Re: Development Application - 16 Gertrude Avenue, Newport

With reference to the Development Application DA2023/0509 of the above property and Council's correspondence dated 9 June 2023, please see attached:

Plans by Taylor Consulting: STORM-1/B and STORM-2:

A1: DRAINS Model for Development

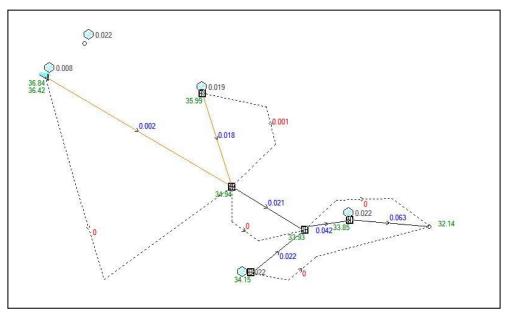
- 1. The plans show the flows from the site are attenuated via the CDC Stage 1 "existing" on-site detention system to be at or below the permissible site discharge rate for all storms up to the 1% AEP. DRAINS modelling software was utilised to undertake the analysis, see attached DRAINS file (refer to Appendix A). The arrangement of the site drainage system achieves the intention of Northern Beaches Council's Water Management for Development Policy for the controlled discharge of stormwater from a site. This is due to the size of the CDC on-site detention system's design, the design provided adequate storage volume to accommodate the additional flows from the Stage 2 works and does not require 80% of the site to be directed to the system to achieve the permissible site discharge. The plans show the site is to be connected via the existing inter-allotment drainage system to the Council network in Walworth Avenue refer to Appendix B for site photos and Appendix C STORM-1/B;

- 2. The DRAINS model has been revised to utilise the Initial Loss/Continuous Loss model rather than the previous ILSAX model,
